CALL NO. 100
CONTRACT ID NO. 241306
ADDENDUM # 1

Subject: Breathitt County, NHPP 0151 (090)
Letting March 21, 2024

- (1) Added - Traffic Management Plan - Pages 583A-583L of 649
- (2) Revised - Plan Sheets U-039, U-041, U-042, U-044, U-045, U-047

Sheet No.	U-039
City of Jackson - Utility Relocation	BREATHITT COUNTY, KY - KY15, ITEM NO. 376.00
Date	2023-08-17
Drawn By	JCM
Scale	AS SHOWN
Job No.	933.40

CITY OF JACKSON
UTILITY RELOCATION
BREATHITT COUNTY, KY - KY15
ITEM NO. 10-376.00
BUS GARAGE LIFT STATION DETAILS

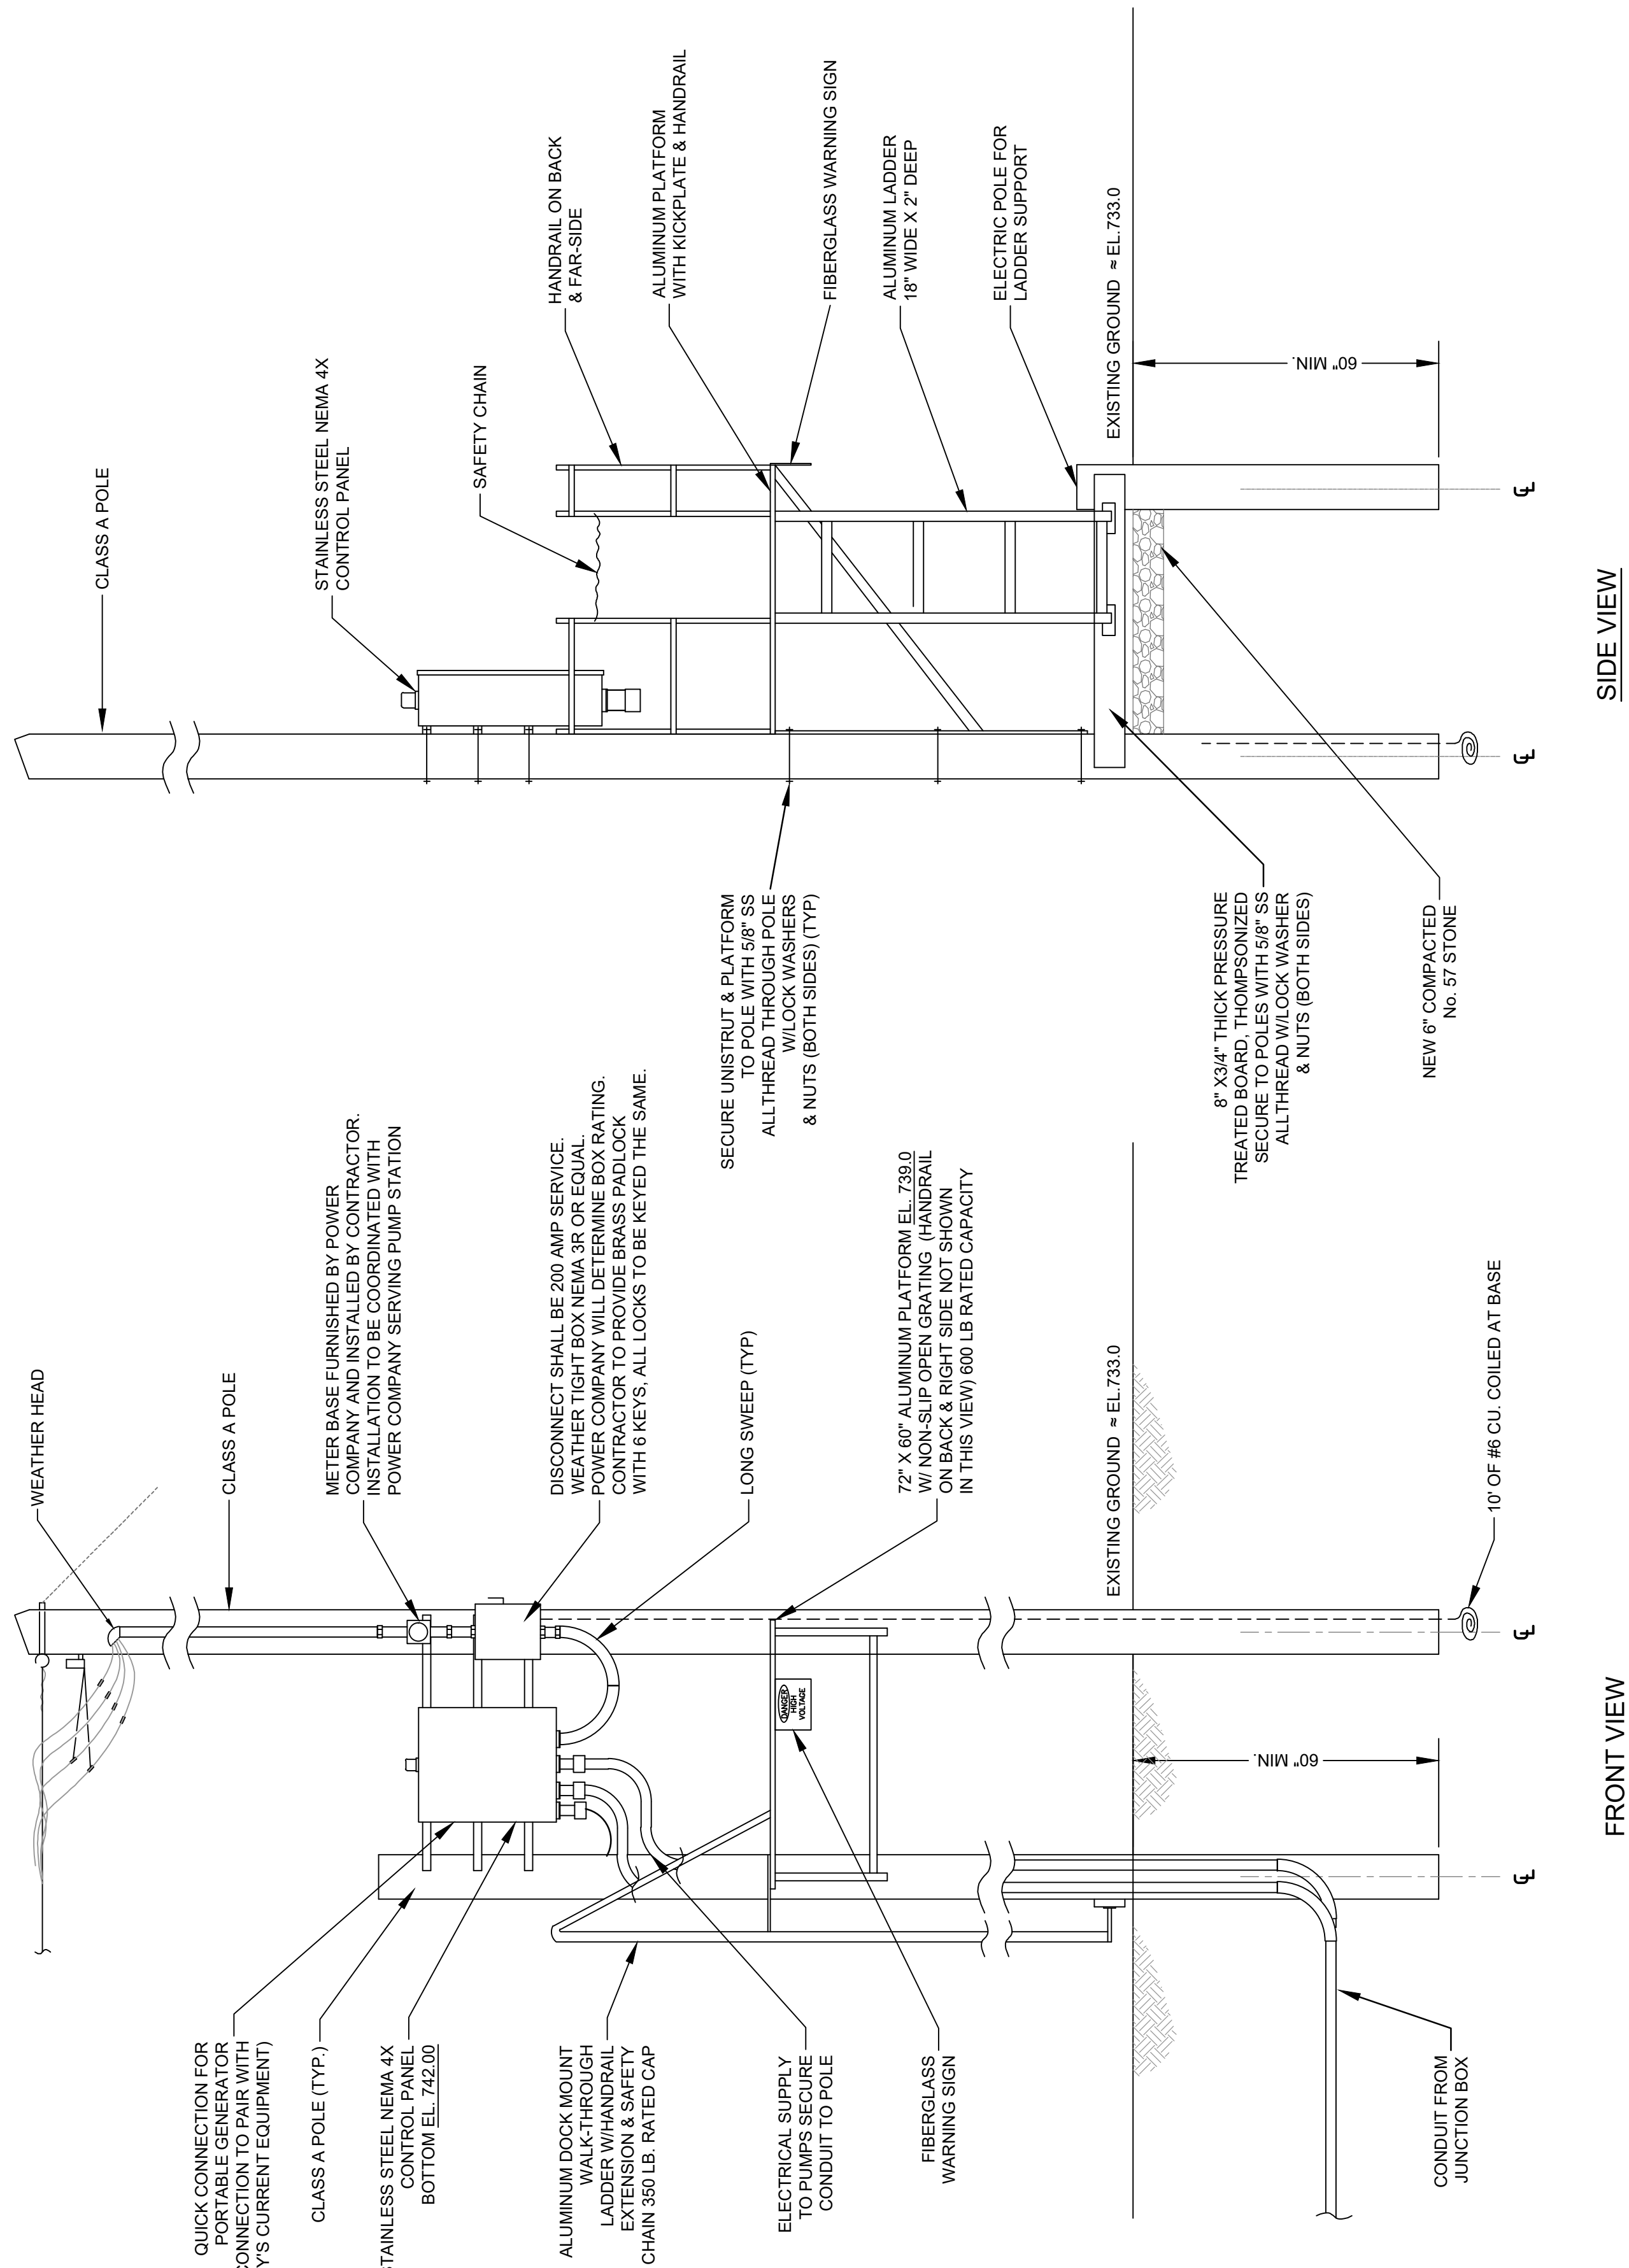
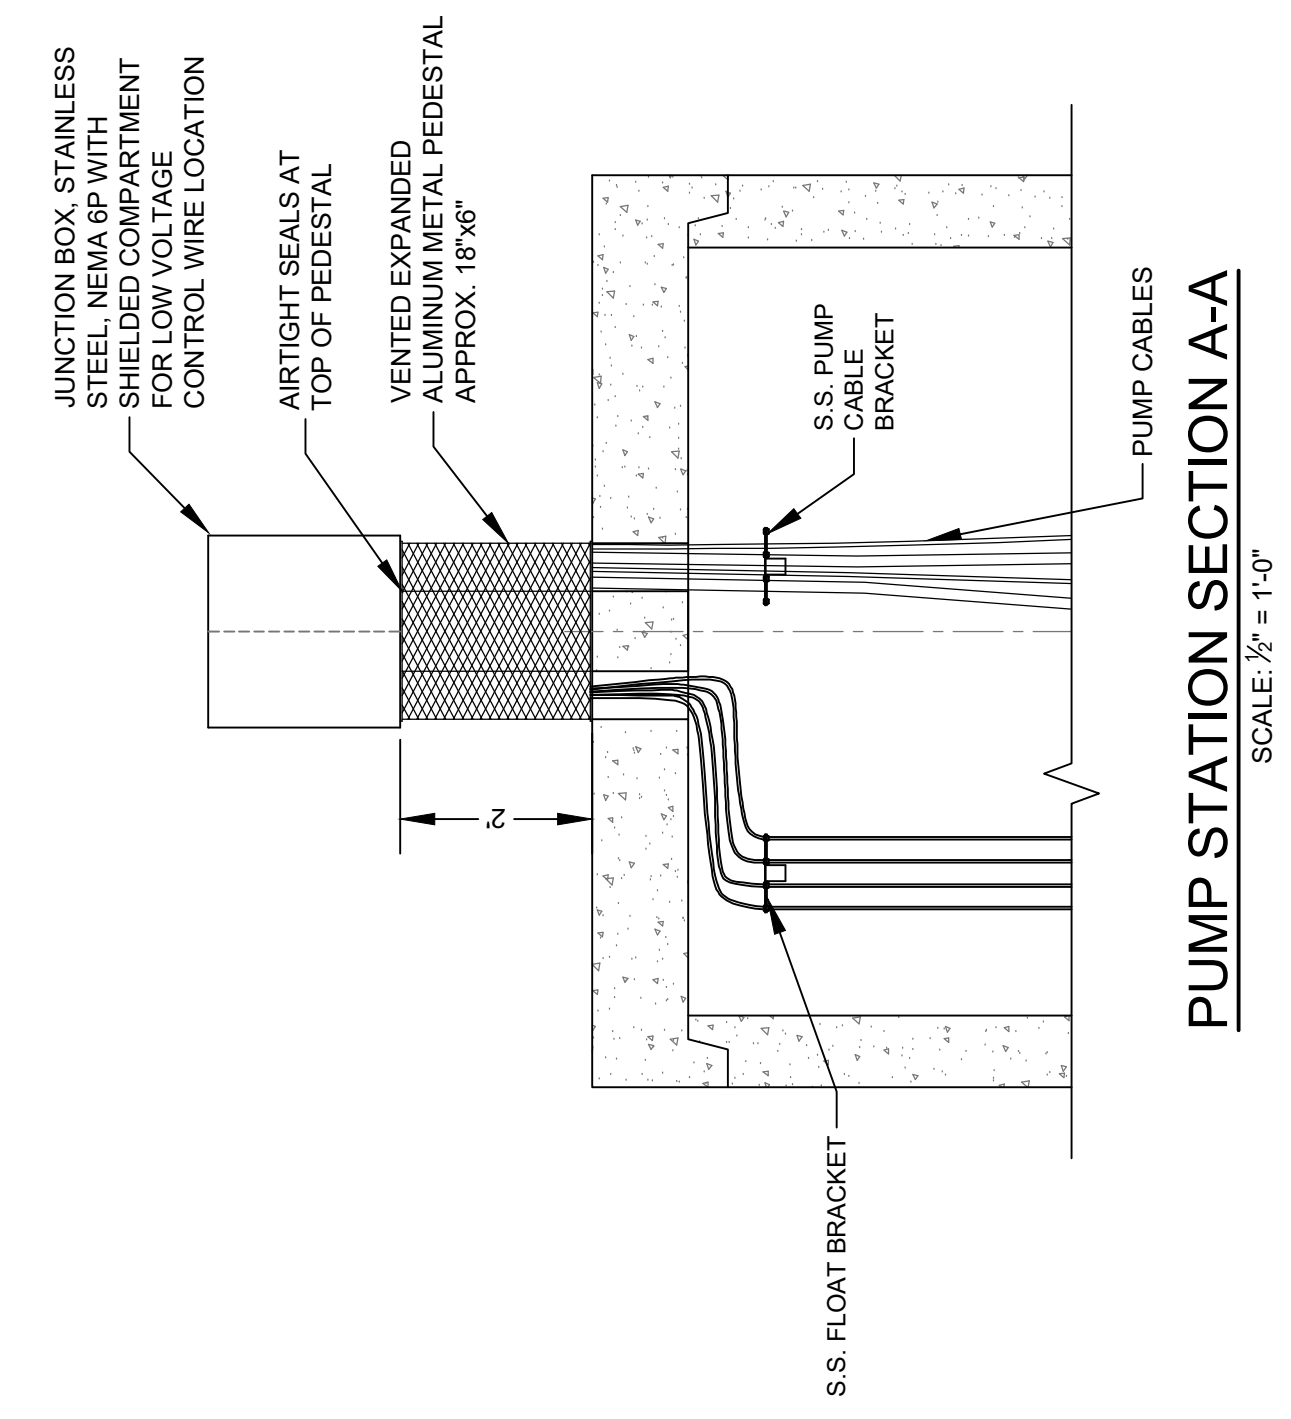
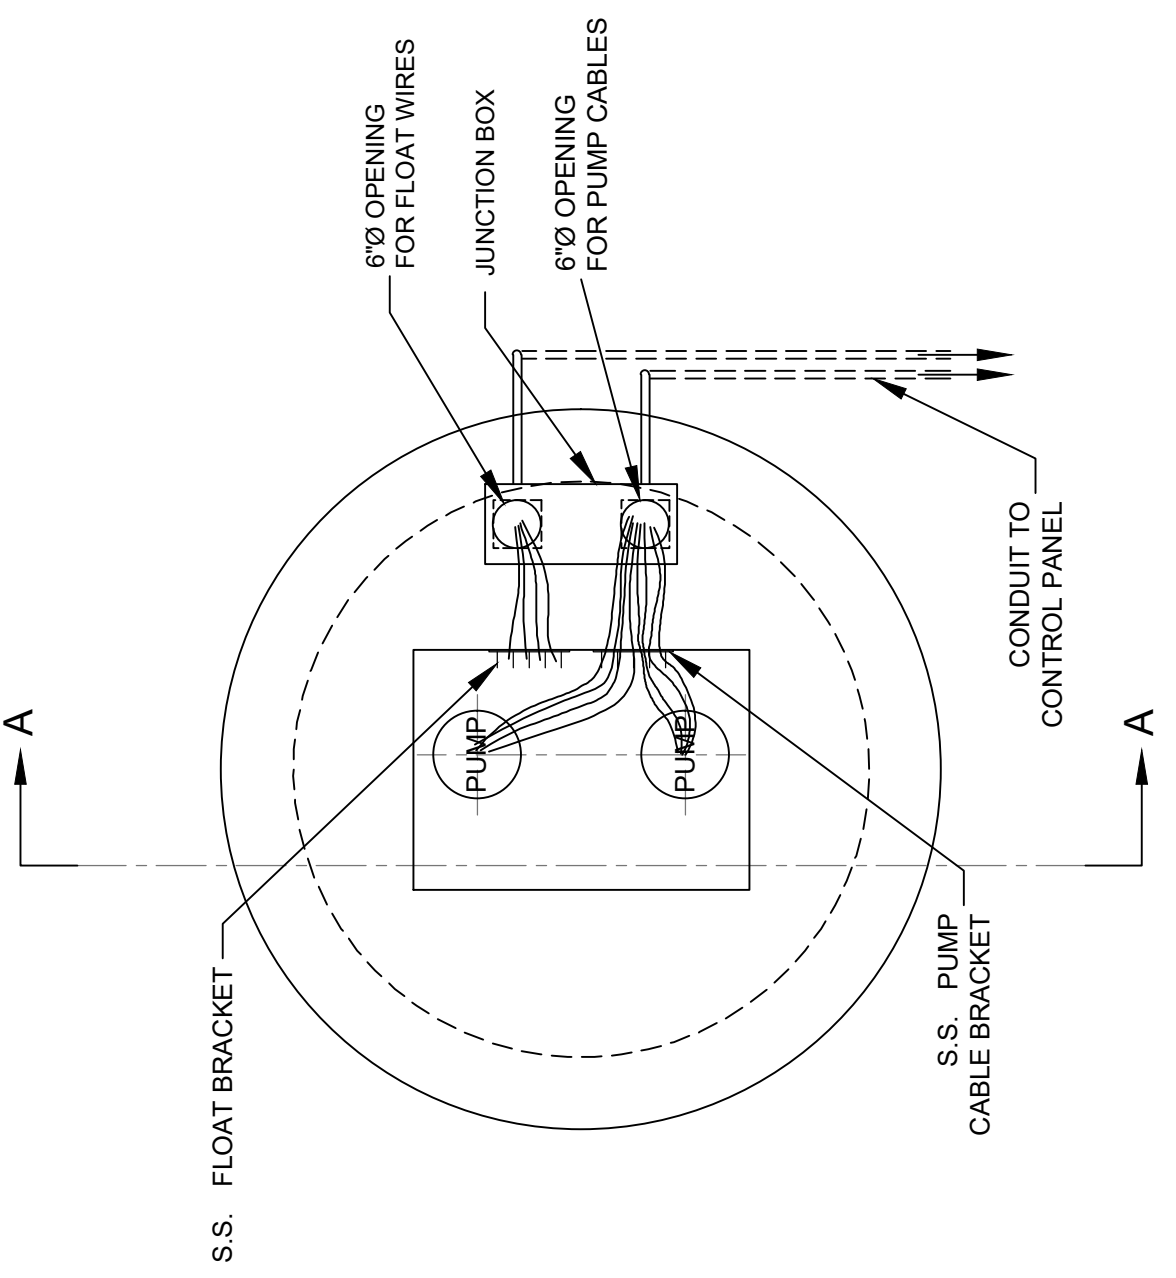
2024-02-20 ADD1 CHANGE JUNCTION BOX TO 6P
REVISIONS
